This is the second letter of review for Variance Application V-20-002 56 Kimble Avenue. The arborist's report contains the information required by the ordinance. There was one difference in professional judgement regarding the proximity of construction and a proposed retaining wall adjacent to coast live oak (*Quercus agrifolia*) #63. The applicant and arborist provided an addendum to address this issue and the revision is satisfactory while providing adequate space and protection of the tree. The plan set still does not contain a T-1 sheet indicating tree protection measures and fence locations and the data table.

I was asked by the Town of Los Gatos to review the plan set and arborist's report for Variance Application V-20-002.

Oak adjacent to proposed retaining wall

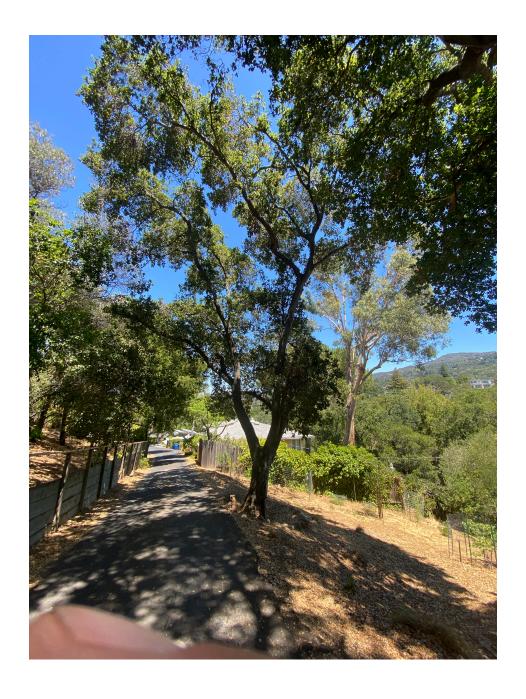
The report contains the typical information required for a predevelopment assessment and conforms with the Town ordinance section 29.10.1000 - New property development. The one conflict around coast live oak #63 has been satisfactorily addressed on the plans and in the report addendum. The plan set does not contain the required T-1 sheet.

- 2. Wrap the trunk of coast live oak #63 with straw wattle or provide a barrier to prevent mechanical damage. Have an ISA Certified Arborist® observe the trenching and provide guidance to selectively remove any significant roots (roots greater than one inch in diameter (1") if encountered. Selective root removal requires pre-excavation, typically by hand or with a pneumatic excavating equipment such as an Air Spade®, Air Knife®, or similar tools. Selective removal allows for the roots to be exposed prior to cutting at the appropriate locations. This is the type of root removal that will need to occur at the building foundation. Roots greater than one inch in diameter should be pruned rather than left torn or crushed so as to leave "a clean flat surface with intact surrounding bark" (Costello, L., Watson, G., Smiley, E. T.. 2017).
